PRODUCT CHANGE NOTIFICATION

#PCN-TT-NFW1-15

Part#	Type Description
2839538	TT-2-PE/S1- 24DC
2920638	TT-2-PE/S1-M-24DC

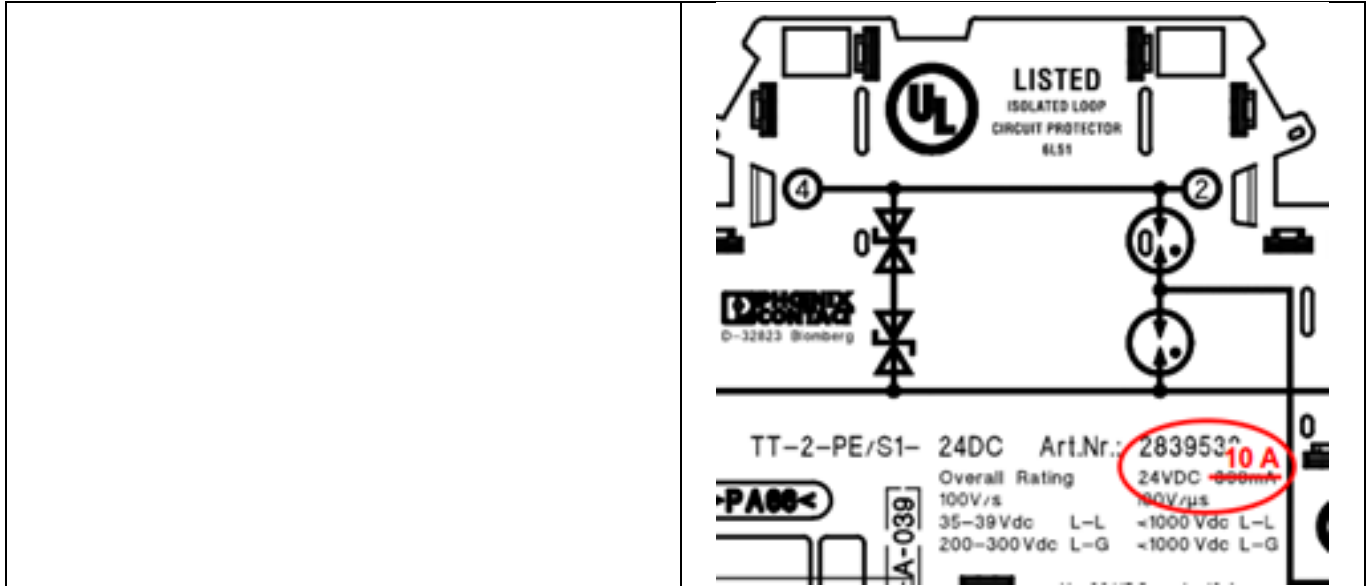
Two TERMITRAB articles received in incorrect rated current level in the UL Report E138168 Vol.1 Sec.15. The correct value is 10 A. The Report is corrected. The printing on the housing of the product has been updated to reflect the correction.
